Mission Terrace Land Preservation Committee

The Mission Terrace Land Preservation Committee (MTLPC) is hereby appealing the issuance of the Categorical Exemption for the development proposed for 203 Cotter Street, Case # 2015-003791ENV, dated September 27, 2016. The exemption should not have been issued based on Section 15300.2.(c) of the California Environmental Quality Act (CEQA) Guidelines which states that "A Categorical Exemption shall not be used for an activity where there is a reasonable possibility that the activity will have a significant effect on the environment due to unusual circumstances." The proposed project would have significant adverse environmental impacts on the neighborhood. These impacts have not been adequately addressed and require further study and analysis in an Initial Study followed by either a Mitigated Negative Declaration or Focused Environmental Impact Report.

Certificate of Determination Exemption from Environmental Review

Case No.: 2015-003791ENV
Project Title: 203 Cotter Street
Zoning: Residential -House, One Family (RH-1)
40-X Height and Bulk District
Block/Lot: 6795A/029
Lot Size: 30,744 square feet (0.71 acres)
Project Sponsor: Jessie Elli

Figure 1 - Proposed Site Plan

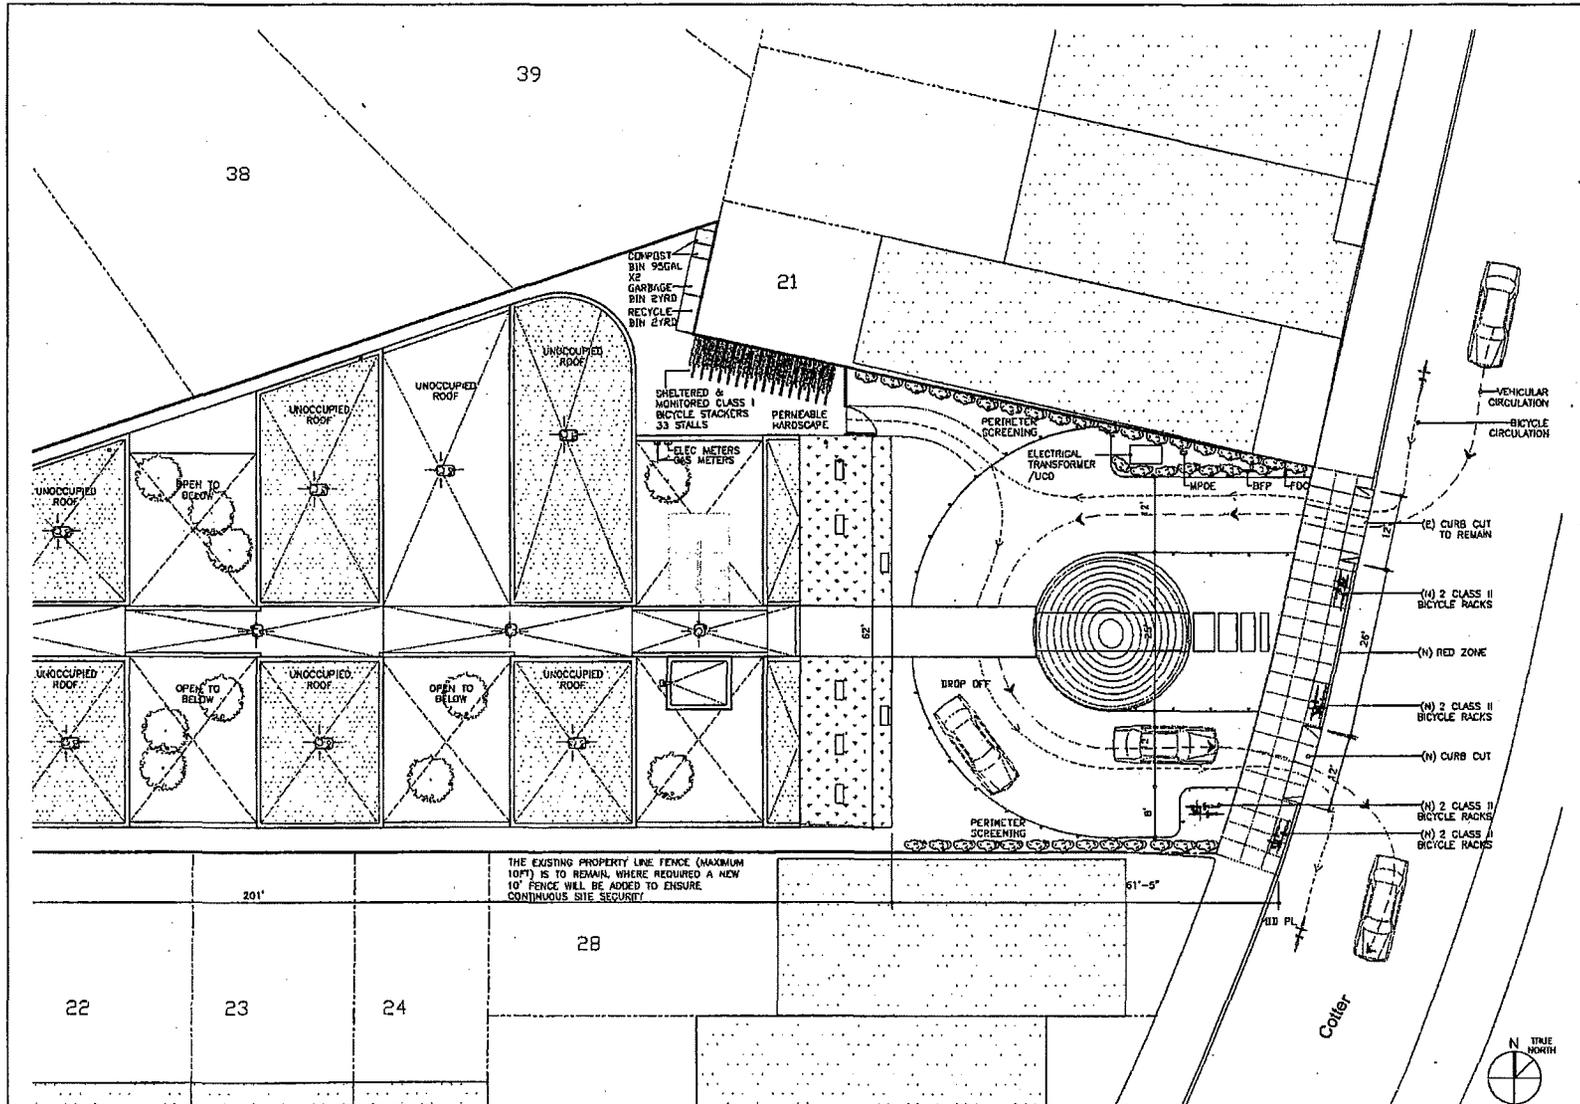
Traffic and Parking. This proposed project will create a substantial amount of traffic on Cotter Street, which is a narrow one- way street already beset with traffic congestion and lack of available parking. Cotter is 35 feet wide and only allows for one car passage at a time. Cotter Street is also a major thoroughfare for cars driving from San Jose Avenue to Alemany or Mission Streets. The traffic memo generated by the project sponsor states that that pick-up and drop-off will generate 184 additional trips, but only 54 will be via car. This seems very low compared to most school situations and quite unlikely to be the real life daily scenario.

Ensuing backup of even a fraction of the unlikely figure of 54 cars would likely mean that Cotter Street is fully backed up potentially close or onto San Jose Avenue, at which point the Muni J line comes out of the San Jose Avenue tunnel and could be dangerously blocked.

FIGURE 3: Low lying and ponded areas in the Cayuga Focus Area. Circle to left indicates existing topography lower than Cayuga Street. Smaller circle to the right indicates area of surface ponding at “foot of Cayuga.” Source: Brown & Caldwell et al., Tech. Memo No. 504, 2009.

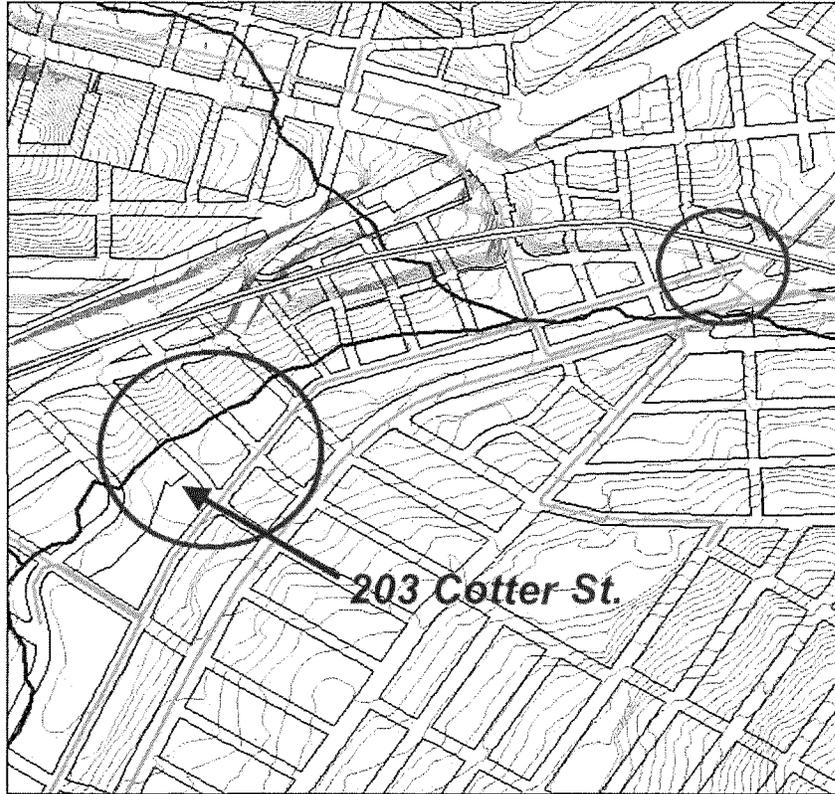
A number of lots in the Cayuga Focus Area are built within the historical creek, including 203 Cotter Street (Figure 3). In these areas, the lots and houses are at a lower elevation than the surrounding streets. This is the case along Cotter Street running north of Cayuga Avenue, which displays a pronounced dip centered on the former creek alignment located at 203 Cotter Street (SFPW, 2016). As illustrated on a sewer as-built drawing for Cotter Street provided in Sherwood Design Engineers 2015 drainage study report (provided as Attachment A), the low spot in the Cotter Street dip is 110.6-feet in elevation (City vertical datum) at the north end of the Project lot. Street elevations rise when moving away from this point in both directions. The road elevation at the Cayuga-Cotter Streets intersection is at an elevation of 113.4-feet (see Attachment A). When the Cayuga Avenue sewer at the intersection of Cotter Street is surcharged, there is no way flow generated on local properties can enter the sewer, even if the hydraulic grade line is lower than the ground on Cayuga Avenue itself. Instead, water flowing out of the surcharging Cayuga Avenue sewer would flow north on Cotter Street to the low point in front of the

Project site. Based on review of available LiDAR data¹ for the project area, portions of the 203 Cotter Street lot lie 1.0-foot below street elevation and 1.5-feet below curb elevation. Thus, the site acts as a small detention basin that can receive and hold flood waters entering from the street or surrounding properties. This topographic setting is also illustrated in the shaded relieve map (Figure 6) presented in the San Francisco Public Works memorandum dated May 27, 2016. Once the lot becomes fully ponded to the elevation of the street curb, local area topography is such that flood water would flow to the Northeast, centered on the 200 Cotter Street property, located opposite of the Project parcel.

Based on the Golden Gate LiDAR, I estimate that there is currently approximately 6000-cubic feet (0.14-acre-feet) of flood water storage below the existing curb crest at the Project property. Based on project plans (Stanley Saitowitz / Natoma Architects, 2016a and 2016b) and statements in the geotechnical report (Rollo & Ridley, 2015), the project proposes to fill site grades up to, if not higher, than the existing curb height. This Project action will effectively eliminate the existing flood storage available to the Project property. This will result in forcing approximately 6000-cubic feet of flood waters onto surrounding properties that otherwise currently is detained on the Project lot during flood events when the Cayuga trunk line is over capacity and surcharging. Based on my understanding of the local area topography, most of this water would be directed onto properties directly across the street from the Project site imparting potentially larger magnitude, higher frequency and longer duration flows, which will all contribute to greater potential flood damages than currently exist.

Figure 4: Islais Creek Historic Map

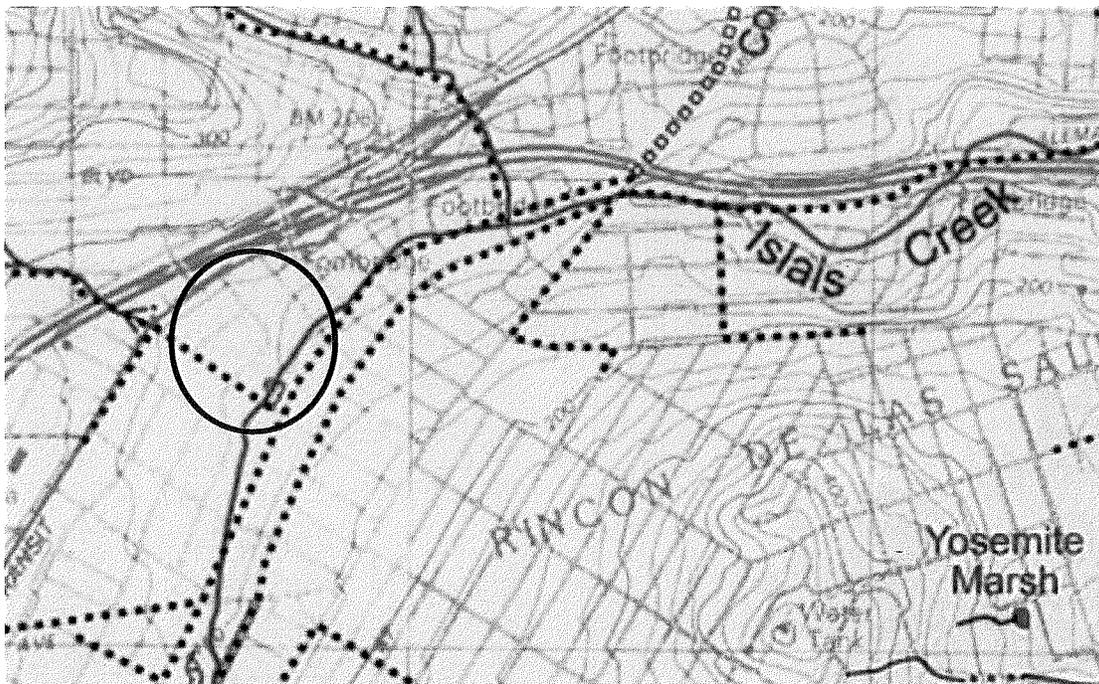
1. Is 203 Cotter St. part of the Islais creekbed? Figure 4 has the property in the red circle. The Islais Creek bed, in green, clearly travels through 203 Cotter St.

Figure 7: 203 Cotter St. 100 Year Floodmap

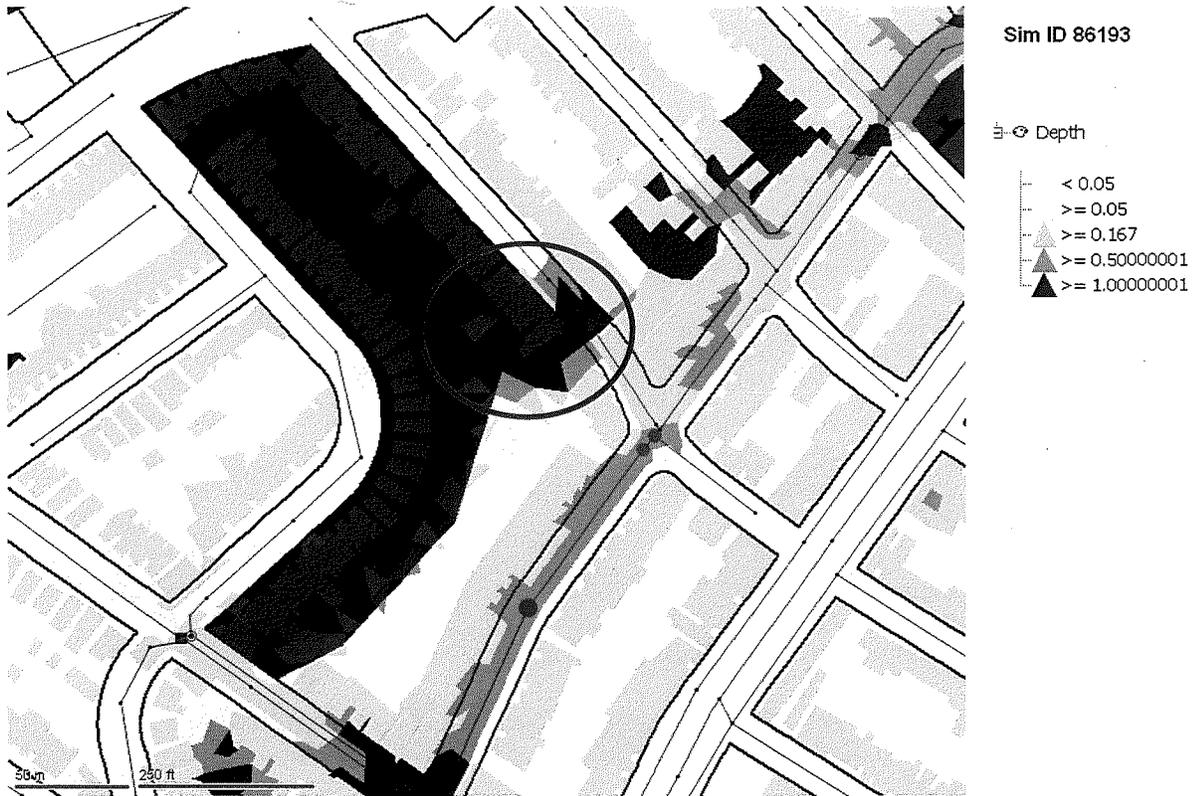
Figure 7 shows flooding as a result of the 100 year storm. The source of model results is the Flood Resilience Baseline, 100-year storm simulation. The area of lowest elevation on 203 Cotter St. bordering Cotter St. is circled in red.
